UNITED STATES OF AMERICA  
NUCLEAR REGULATORY COMMISSION

TEXAS UTILITIES GENERATING  
COMPANY, et al.

(Comanche Peak Steam Electric Station  
Station, Units 1 and 2)

CASE'S ANSWER TO APPLICANTS' STATEMENT OF  
MATERIAL FACTS AS TO WHICH THERE IS NO GENUINE ISSUE REGARDING  
CONSIDERATION OF FRICTION FORCES IN THE DESIGN  
OF PIPE SUPPORTS WITH SMALL THERMAL MOVEMENTS

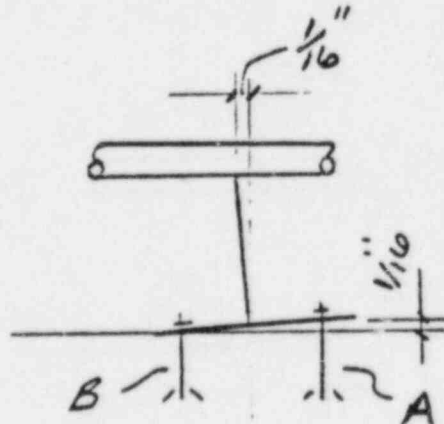
Because this support is short and stiff and bending deformations are neglected, when the pipe moves, it will tend to pull one anchor bolt out an amount equal to the pipe movement, as shown below.

Reviewing the load displacement diagram for a 1/2" diameter Hilti bolt at 1/16" deflection, the load on the bolt (labeled A in the drawing above) would be 4,900 lbs., with the shear load equal to zero and 4,000 psi concrete (see attached 4/15/74 letter from Robert D. Dalton, Jr., President of Abbot A. Hanks Testing Laboratories, to Hilti Fastening Systems, Inc., under Subject of Combined Shear and Tension Testing: KWIK-Bolt). But the allowable is listed as 1,100 lbs. for 2-1/4" embedment, as shown in the PSE Manual (see attached page 8 of 10 of Section V, Hilti Concrete Anchor Bolts, Rev. 0, 1/8/82). Now in the event of a seismic load, this support will only have one anchor bolt (labeled B in the drawing above), since the bolt A exceeded its capacity for predictable behavior.

This example demonstrates two important topics. The first is that when the Applicants neglect friction, they are neglecting an important loading condition. The second and most important is the reason Applicants gave for not considering it. Mr. Finneran stated that the factor of safety for the Hilti bolt was 5 and not 4 (Finneran Affidavit at page 5). As shown in the above example, the Hilti bolt would have been sized for a vertical upward load only, and this would be independent of the effects caused by friction. Mr. Finneran's conclusion does not form a logical basis for not considering friction, in regards to Hilti bolts.
